# **ENVIRONMENTAL STATEMENT: ADDENDUM HALE WHARF**

## HALE WHARF

Revision **02**  
Date **25/01/2017**  
Made by **Lisa Horridge**  
Checked by **Roy Emberton**  
Approved by **Stepan Ruzicka**  
Description **ES Addendum January 2017**

Ref 33510.ESADD.17.2

HALE WHARF  
 BUILDING HEIGHTS COMPARISON  
 SKETCH  
 535\_02\_SK\_111  
 SCALE 1:500 @A1 1:1000 @A3  
 All Intellectual Property Rights Reserved

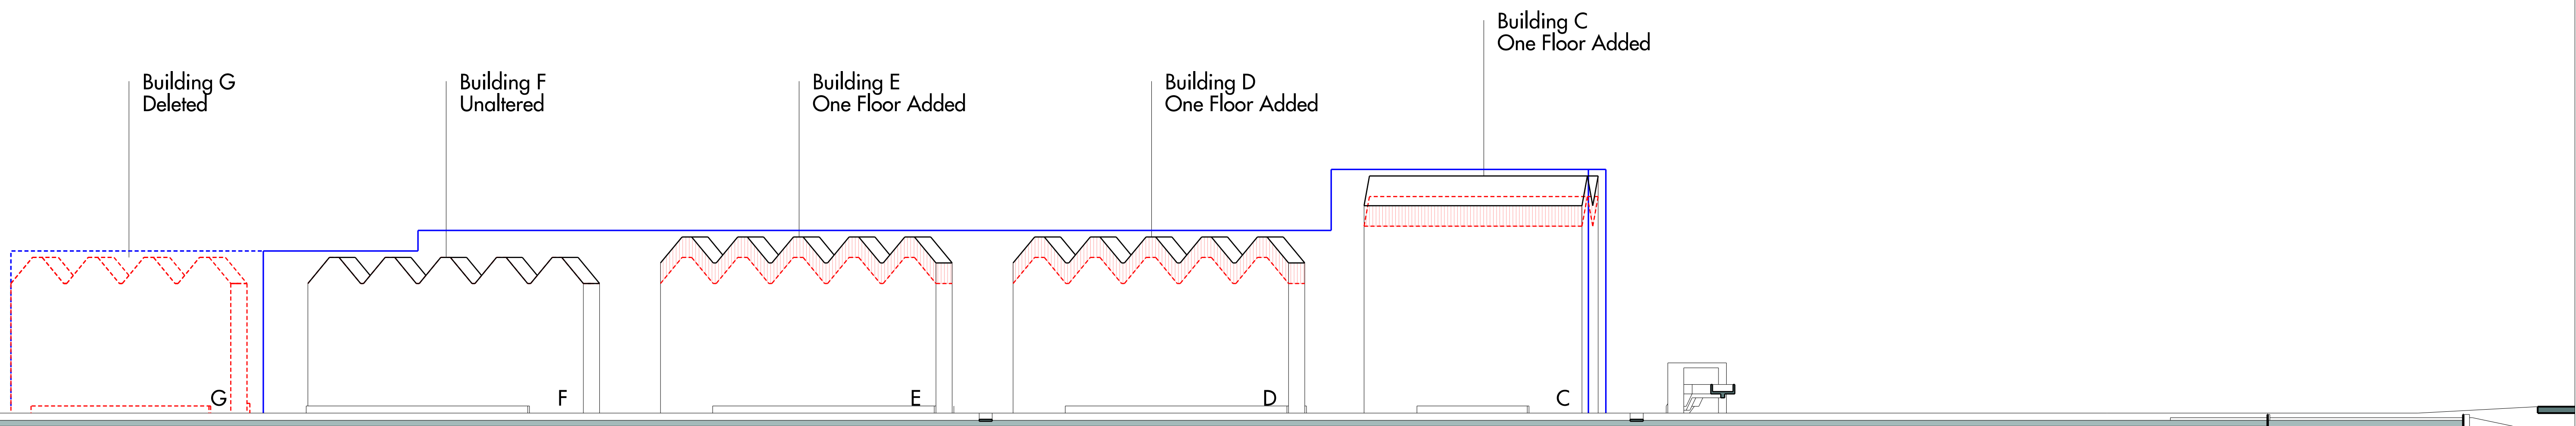
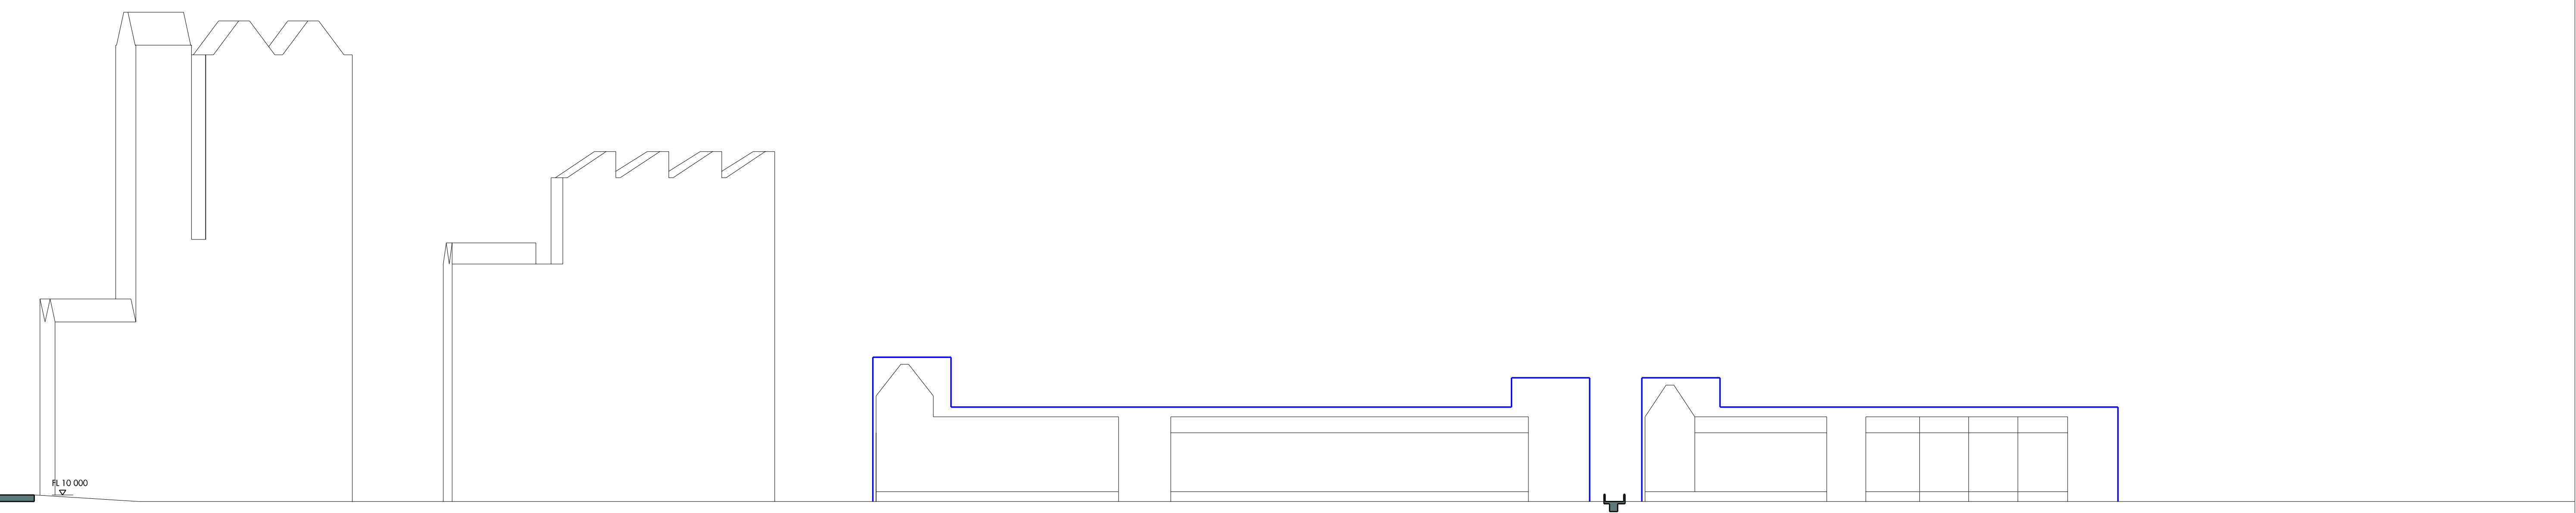
No change is proposed to the maximum number of dwellings (505) or floorspace (46,100 sq.m) to be provided within the development. The revised illustrative scheme at Appendix A shows how there is potential to increase the heights of three of the blocks within the height parameters which were already proposed, whilst staying within the maximum height parameters. Sketch 535\_02\_SK\_111 shows how this can be achieved within the height parameters, whilst omitting Block G.

According to the revised illustrative drawings, Block G is removed, and Blocks C, D and E increase by one floor. The increase in height has the potential to slightly increase the downdraft on the upwind sides of the buildings. However, significant impact on pedestrian level wind conditions is not expected due to the height increase of Buildings C, D and E. The removal of Building G is not expected to have any adverse effects on pedestrian comfort and safety. This is because the removal of the building would only serve to alleviate the effect of funnelling of commonly occurring westerly winds between Block G and the adjacent building, Block F. Moreover, with the removal of Block G, this northernmost portion of the development essentially reverts closely towards existing conditions (where this plot is empty), and where wind conditions are suitable for planned pedestrian uses.

**HALE WHARF**  
**DEVELOPMENT ZONES AT GROUND LEVEL**  
**PARAMETER PLAN**  
**535\_02\_07\_022**  
 SCALE 1:1000 @A3  
 All Intellectual Property Rights Reserved

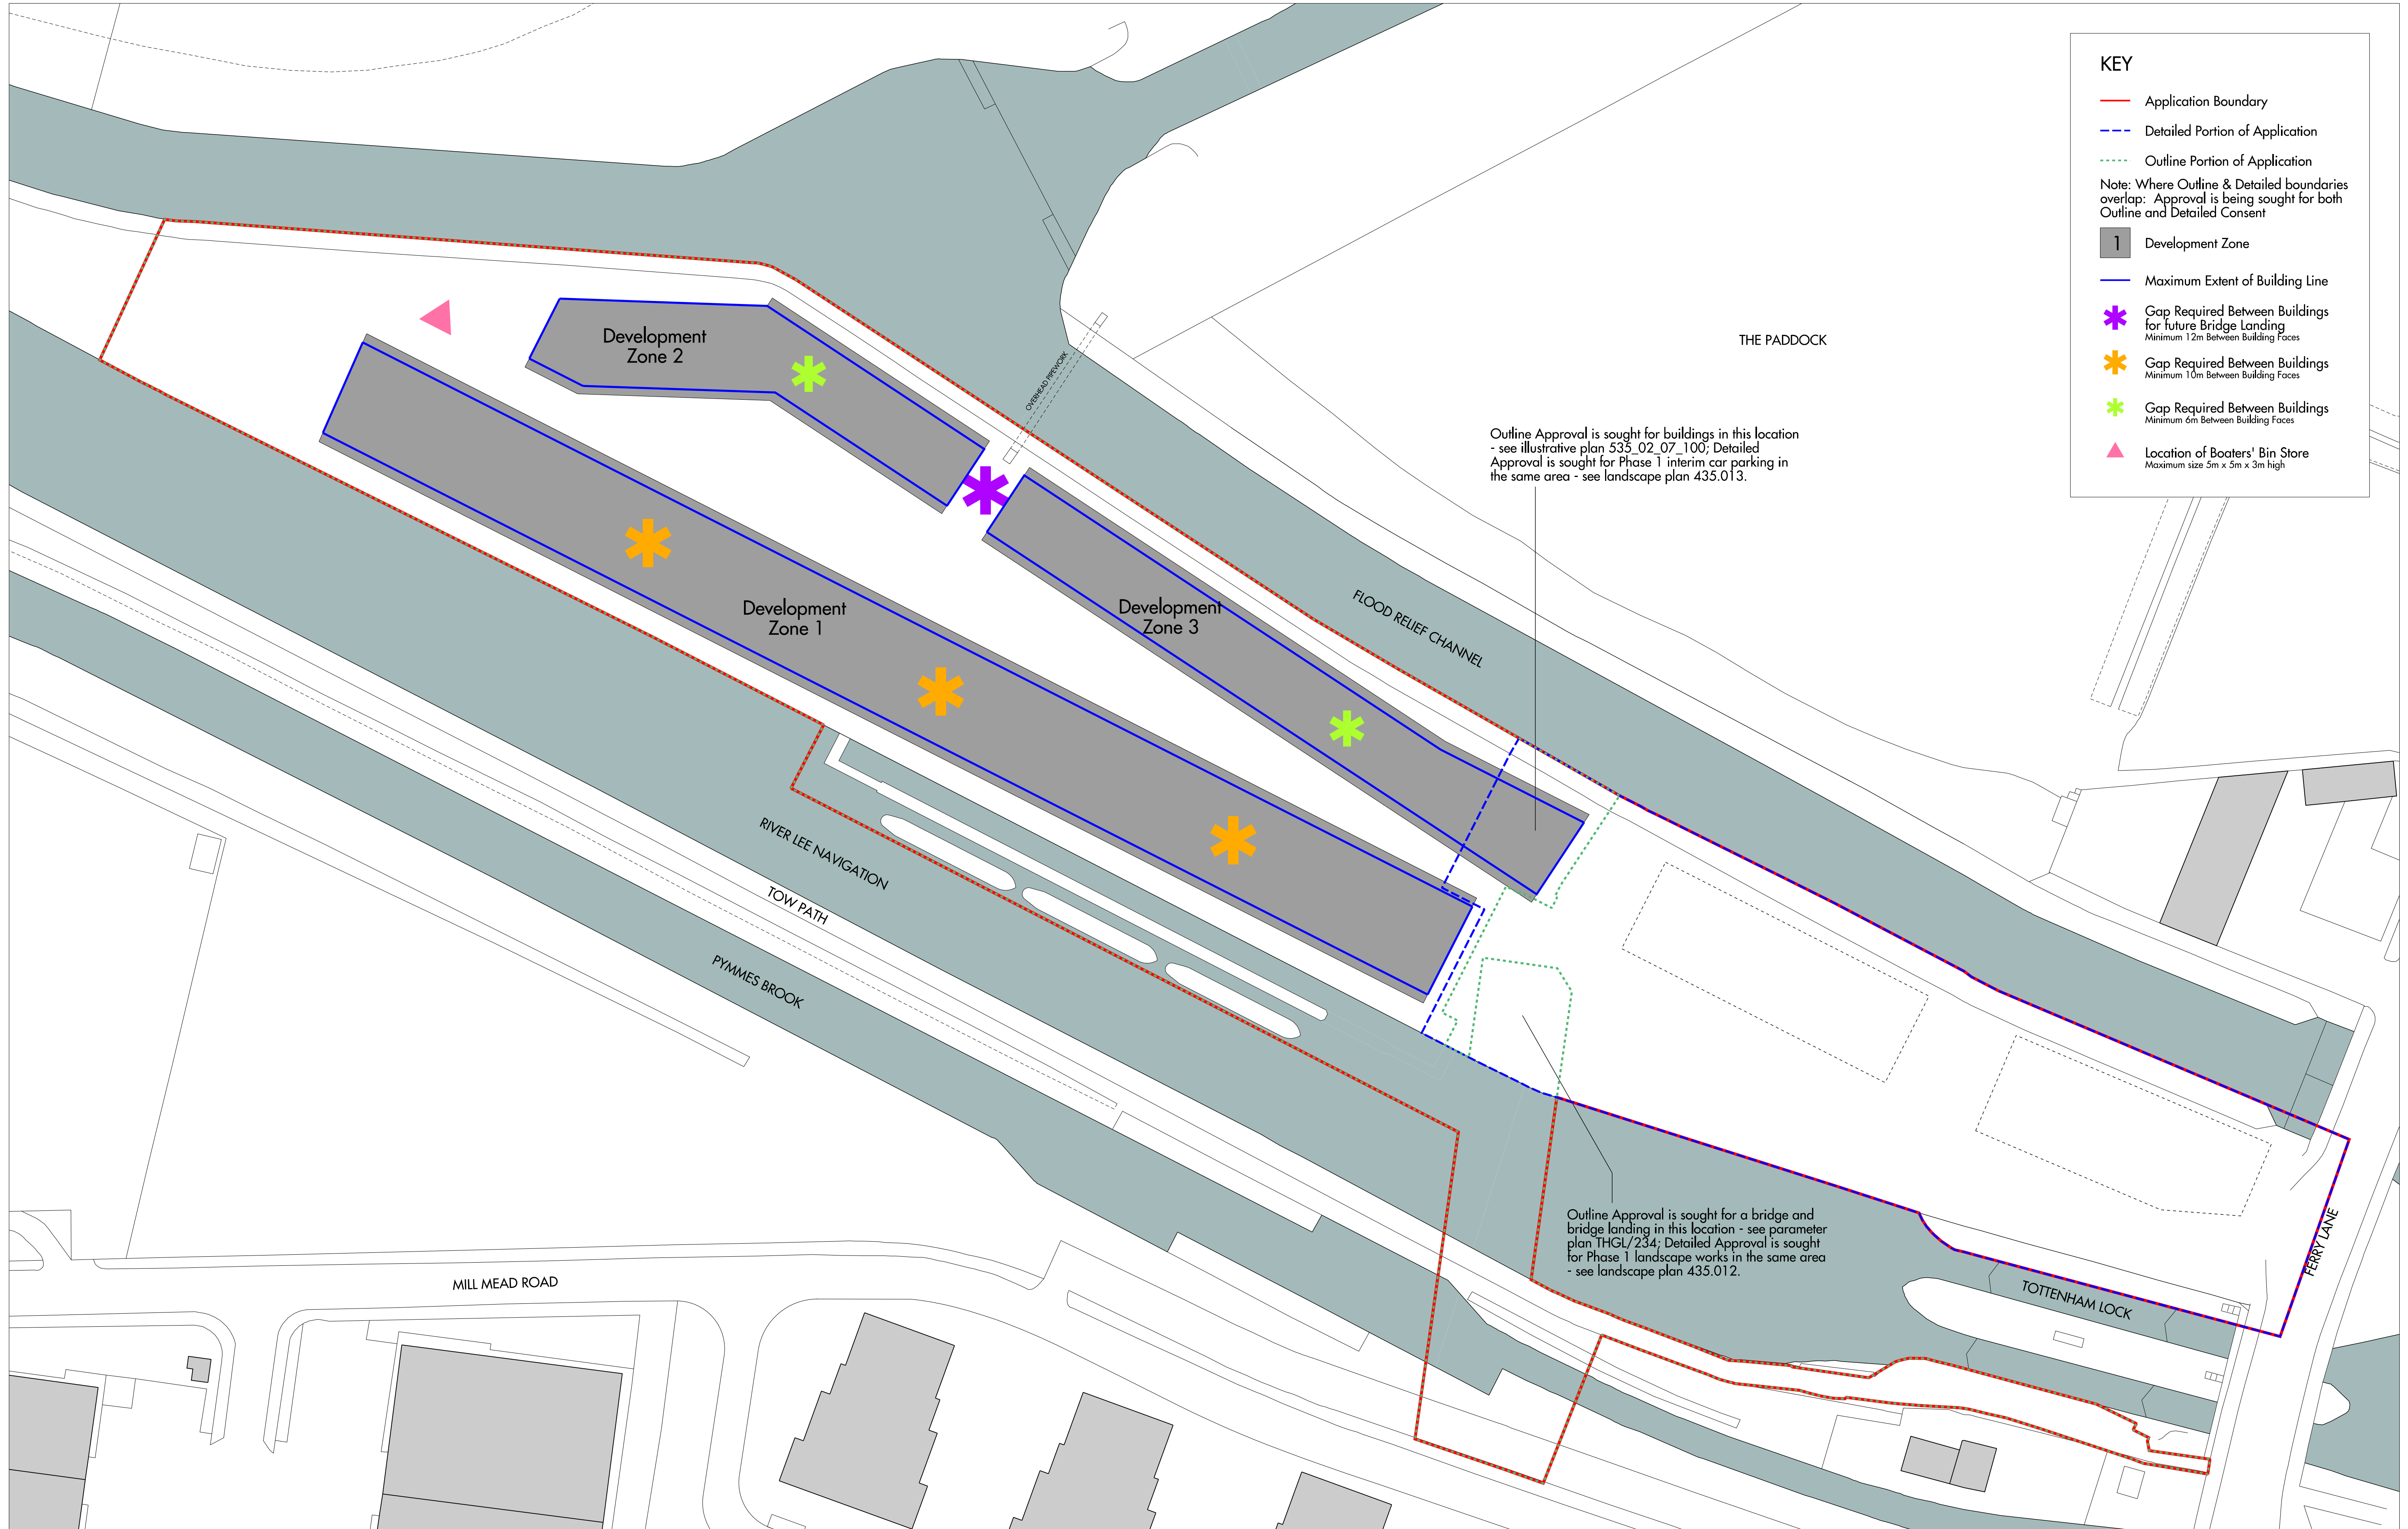
As shown on the revised parameter plans and site wide landscape general arrangements at Appendix A, it is proposed to reduce the development footprint of buildings in the northern part of the application site. The change has been made to remove any ambiguity about whether the proposed buildings would fall within the Green Belt, and to demonstrate that they do not. The maximum building extent shown on the parameters plans has been re-repositioned approximately 38 metres further south, however no changes to the overall maximum height of the building extents have been made. A comparison elevation sketch between the originally submitted illustrative scheme and the now proposed illustrative scheme is provided within the Sketch at Appendix A, as well as the revised planning drawings of the area where buildings can be located (development zone in grey); also provided at Appendix A.

REV	DATE	DESCRIPTION	CKD
PL1	20.05.2016	Issue for Planning	HH
PL2	23.01.2017	Development area amended	HH
